Service Bulletin

Date: March 2, 2015

Bulletin No: JC-15-03

Product Type: Ren-O-Thin

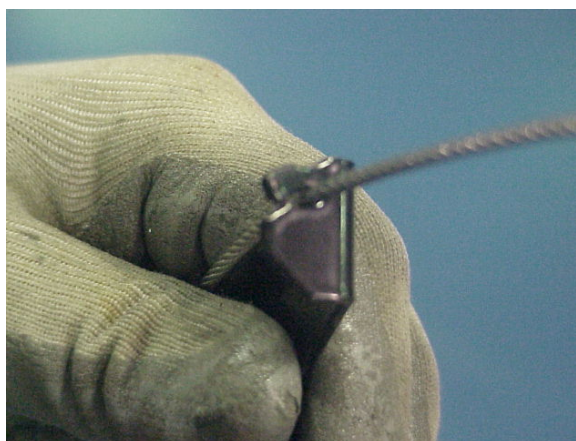
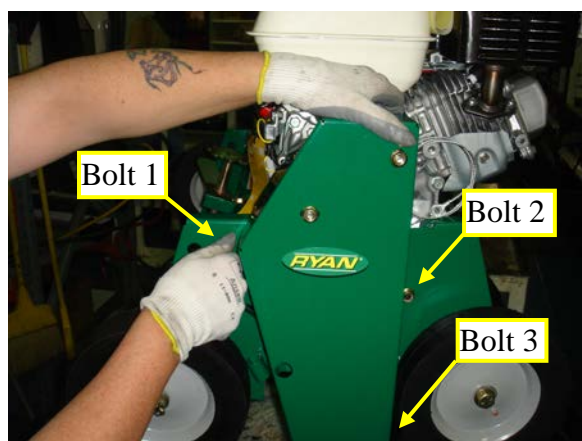
1) Remove the side Cover

The cable is crimped to the deflector arm.

This crimp will have to be spread open but first mark the new cable as shown in the next picture.

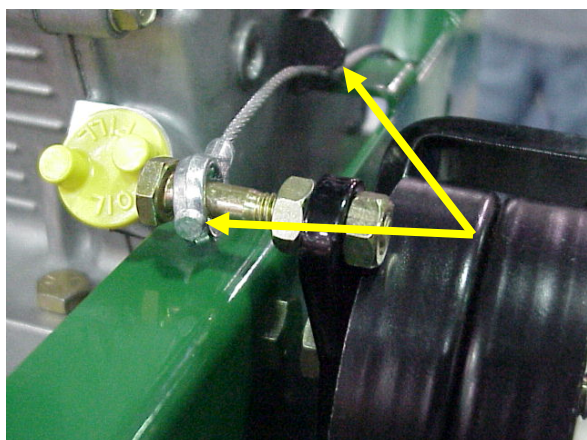
2) Lay the new cable on top of the existing one so you can mark the length where the deflector arm crimps on to it. Now you can spread the clamp to release cable from the deflector arm.

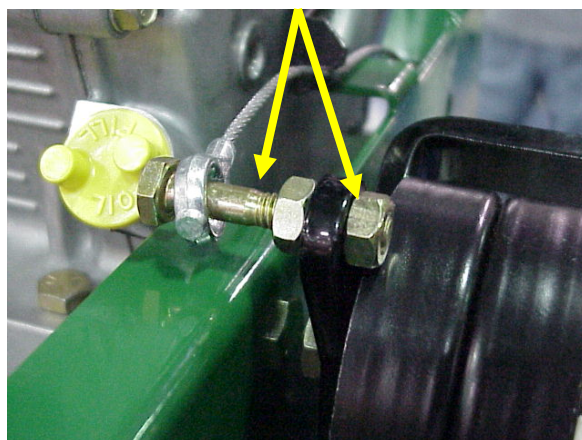
3) Remove the nuts and bolt holding the cable to the idler arm.

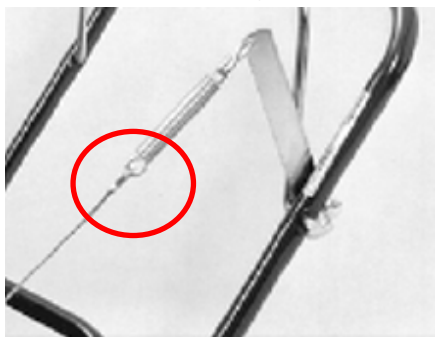
- 4) Put the bolt back through the new cable eyelet and fasten it back on the idler arm.
5) Crimp the deflector arm back onto the cable with the mark you put on the cable from Step 2.
6) Reinstall the belt cover.
7) Attach the other end of the cable to the spring on the handle.
